W3F1-2017-0067

Subject: License Amendment Request to Remove Technical Specification 3/4.3.2
Table 4.3-2 Note 3 Exemption for Testing Relays K114, K305, and K313
Waterford Steam Electric Station, Unit 3 (Waterford 3)
Docket No. 50-382
License No. NPF-38

Waterford 3 Steam Electric Station
Analysis of Proposed Technical Specification Change

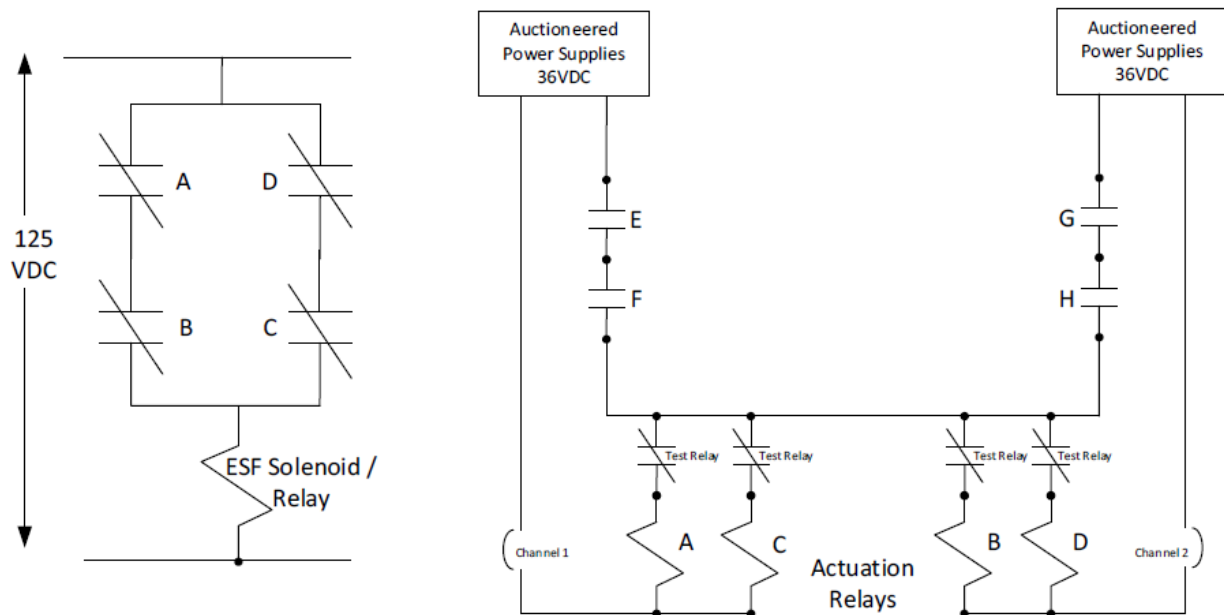
The following figure shows the simplified current configuration of the ESFAS single point vulnerability. This is a generic arrangement for explanation purposes. The specific relay changes will be shown in the next sections.

The ESFAS single point vulnerability is associated with the power supply arrangement. If a short circuit were to occur across the relay A coil, power would be lost to the left half of the ESF bus resulting in the de-energization of relays A and C. Such failures would not affect relays B and D as these have a separate negative and circuit breaker. Under this scenario, the ESF equipment associated with relay A would actuate. This is the single point vulnerability identified for MSIS relays K305 and K313, and for CSAS relay K114.

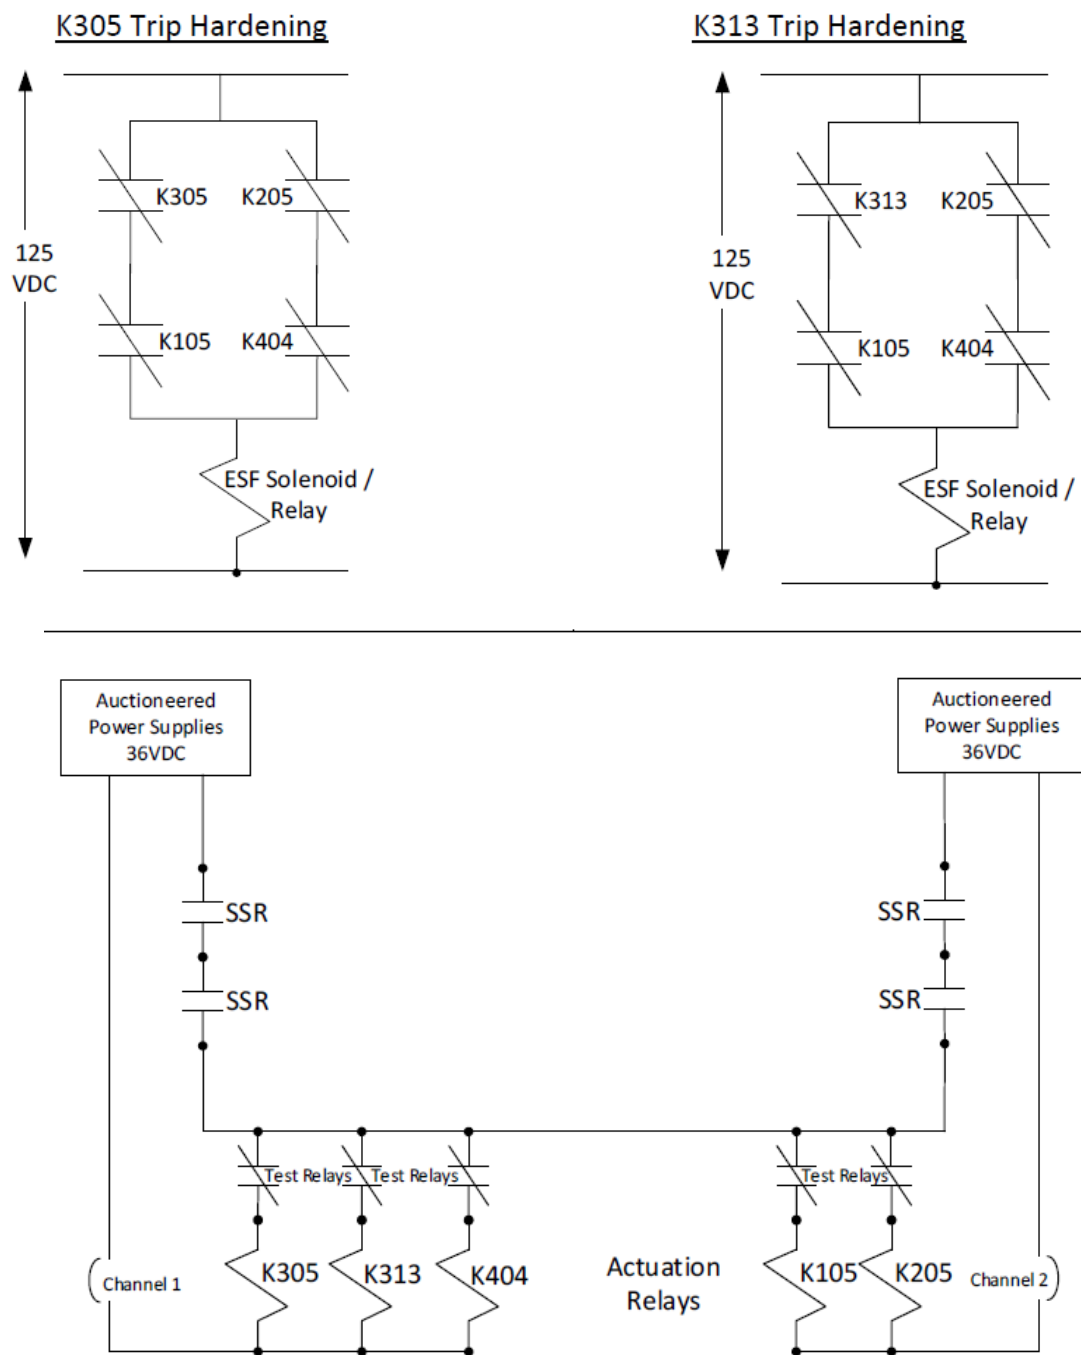
The K305 relays will be trip hardened by adding 3 additional relays creating a 2 out of 2 paralleled with 2 out of 2 logic scheme. Spare relays used to trip harden the K305 relay are K105, K205, and K404. K305 and K404 are powered from one power supply while K105 and K205 are powered by a separate power supply. K305 trip hardened contacts are wired in series with K105 contacts. K205 contacts are wired in series with K404 contacts. K305 AND K105 OR K205 AND K404 are required to close to actuate associated downstream ESF equipment.

The K313 relays will be trip hardened by adding 3 additional relays creating a 2 out of 2 paralleled with 2 out of 2 logic scheme. Spare relays used to trip harden the K313 relay are K105, K205, and K404. K313 and K404 are powered from one power supply while K105 and K205 are powered by a separate power supply. K313 trip hardened contacts are wired in series with K105 contacts. K205 contacts are wired in series with K404 contacts. K313 AND K105 OR K205 AND K404 are required to close to actuate associated downstream ESF equipment.

The following figure is a simplified diagram of the scheme.

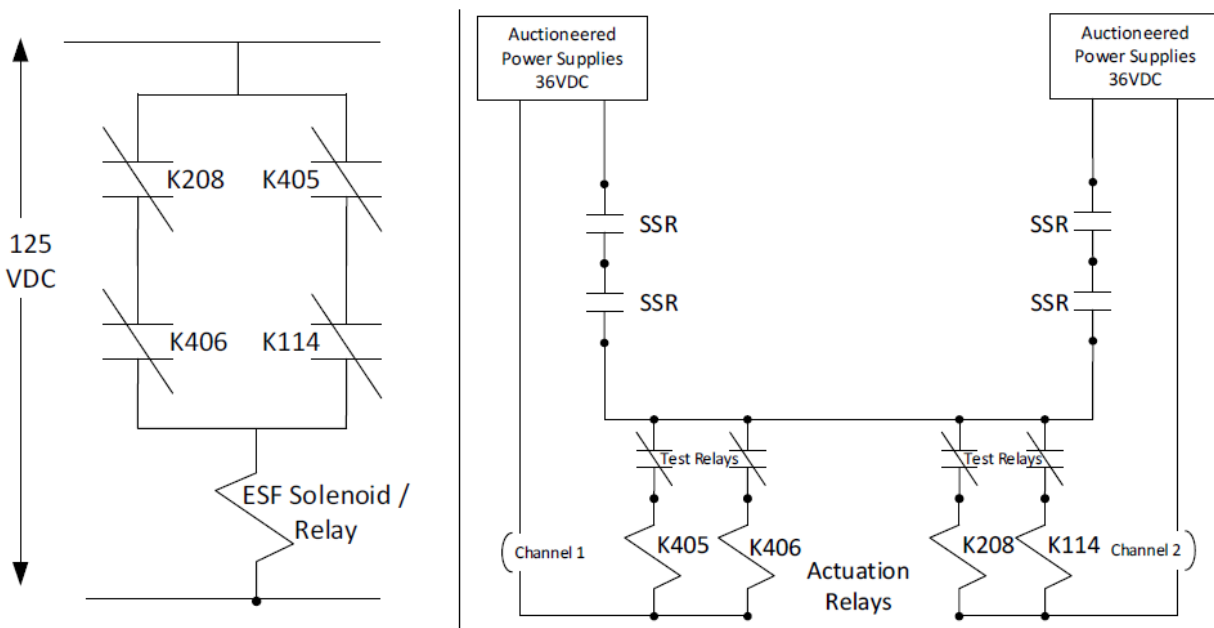
The K114 relay will be trip hardened by adding 3 additional relays creating a 2 out of 2 paralleled with 2 out of 2 logic scheme. Spare relays used to trip harden the K114 relay are K208, K405, and K406. K114 and K208 are powered from one power supply while K405 and K406 are powered by a separate power supply. K114 trip hardened contacts are wired in series with K405 contacts. K208 contacts are wired in series with K406 contacts. K114 AND K405 OR K208 AND K406 are required to close to actuate associated downstream ESF equipment.

The following figure is a simplified diagram of the scheme.

Test Switch and Test Relays

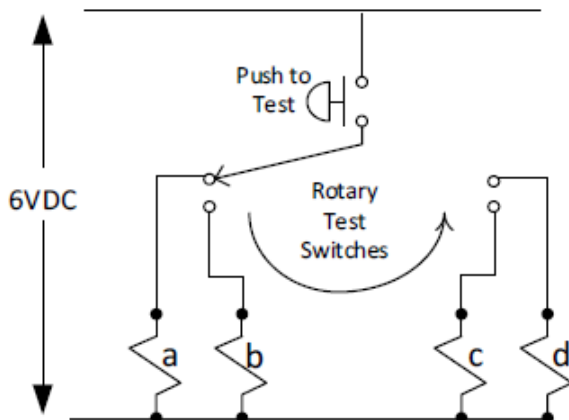
Spare relays used in the trip hardening scheme have associated test relays located in the ESFAS cabinets that are pre-wired to test switches in the Control Room. This wiring exists currently for the spare actuation relays. This change will take advantage of the pre-wired test relays and switch positions to incorporate both discrete online testing and gang operated offline testing that will test both actuation relays and downstream ESF devices. The next figure is a simplified version of the test switch arrangement and how it discretely controls the actuation relays. This figure represents any given ESFAS actuation relay (A, B, C, D) and its test relay pair (a, b, c, d). By aligning the rotary switch to the "c" position and pressing the test pushbutton, "c" test relay would be energized by the 6 volt source and its associated normally closed contact in series with ESFAS actuation relay "C" would be de-energized from its 36 vdc source. The testing of actuation relay "C" is achieved without dropping out the entire actuation relay bus. This same method is employed for each actuation relay. By trip hardening the relays with 3 other relays, a single relay no longer actuates the downstream ESF function and can be tested at power. This design change assigns existing spare switch positions in the control room to allow testing of each trip hardened relay.

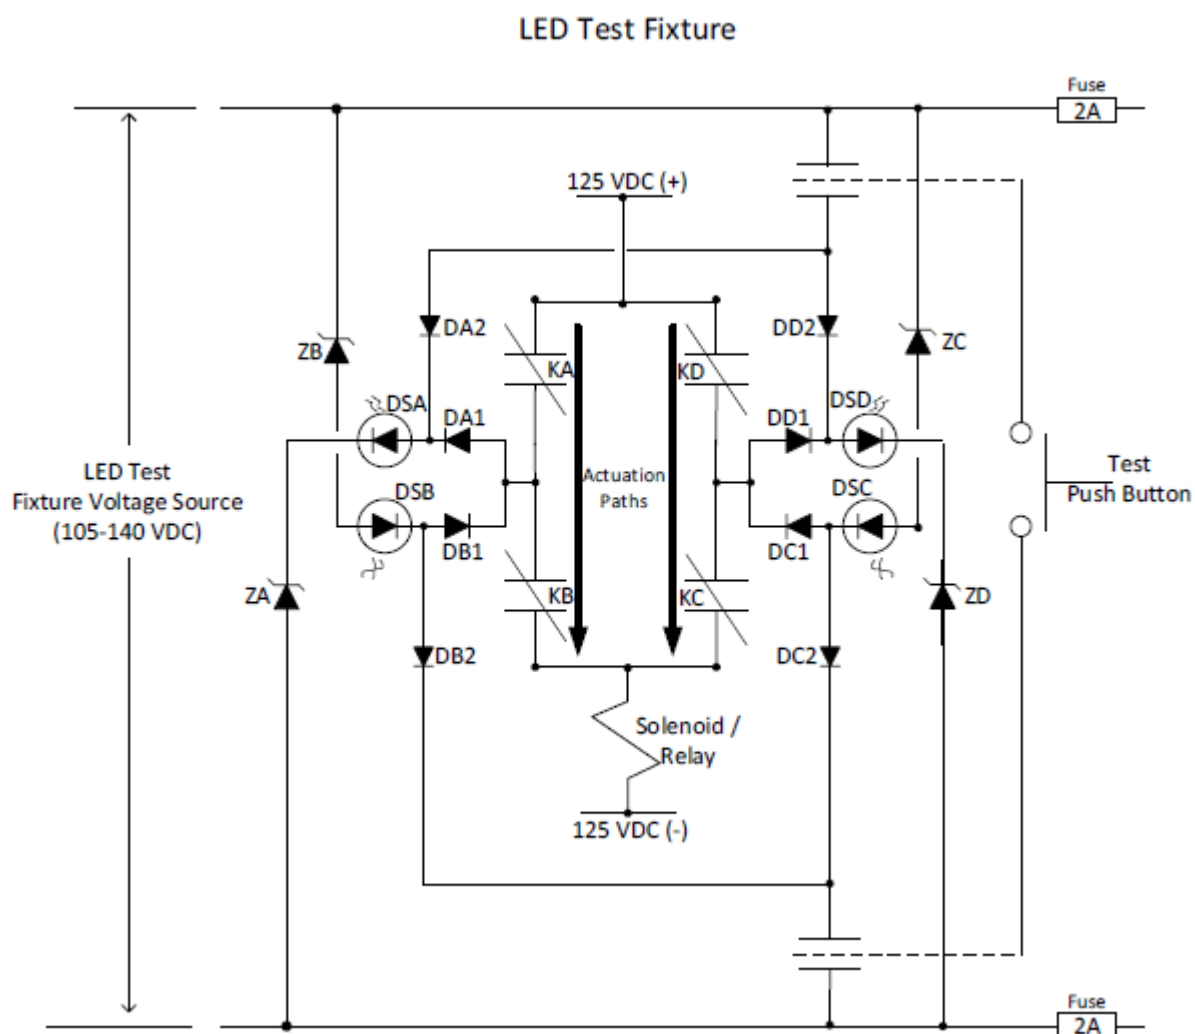
The LED Test Fixture provides light indications of trip hardened contact closures during testing. The LED Test Fixture is also used during normal operating rounds to verify trip hardened relays have not failed during the operating cycle. A test pushbutton is provided for lamp checks during operator rounds to verify all LEDs are in working order.

During a full actuation of either CSAS or MSIS, either by gang operation during offline testing or by actual ESFAS signal received due to an event, the LED Test Fixture is not used. This is acceptable as full actuations are verified by proper operation of the downstream ESF component indications (valve closes, pump starts, etc.). Existing indications in the control room will continue to be relied upon for ESF component response during MSIS and CSAS full actuations with no changes required.

The next figure is a simplified diagram of the LED Test Fixture. KA through KD are the subgroup actuation relay contacts. DSA through DSD are the LEDs used to monitor their respective actuation contact. The following examples assume all contacts are open unless stated otherwise. As an example, assume Operations is performing an online surveillance test of each relay (KA, KB, KC, KD) discretely, meaning only one is being tested at a time. The first step Operations will perform is verifying the LEDs are working properly by depressing the 'Test Push Button.' Once all LEDs are verified illuminated, the pushbutton will be released, extinguishing the LEDs. Next, Operations will verify no LEDs remain illuminated (which would indicate a failed actuation relay or contact). Once all LEDs are verified extinguished, testing may be performed. Assume KA is under test. Contact KA is monitored by LED DSA. When KA is closed, DSA is illuminated (ON). When KA is open, DSA is not illuminated (OFF). The remaining LEDs (DSB through DSD) function in the same manner.
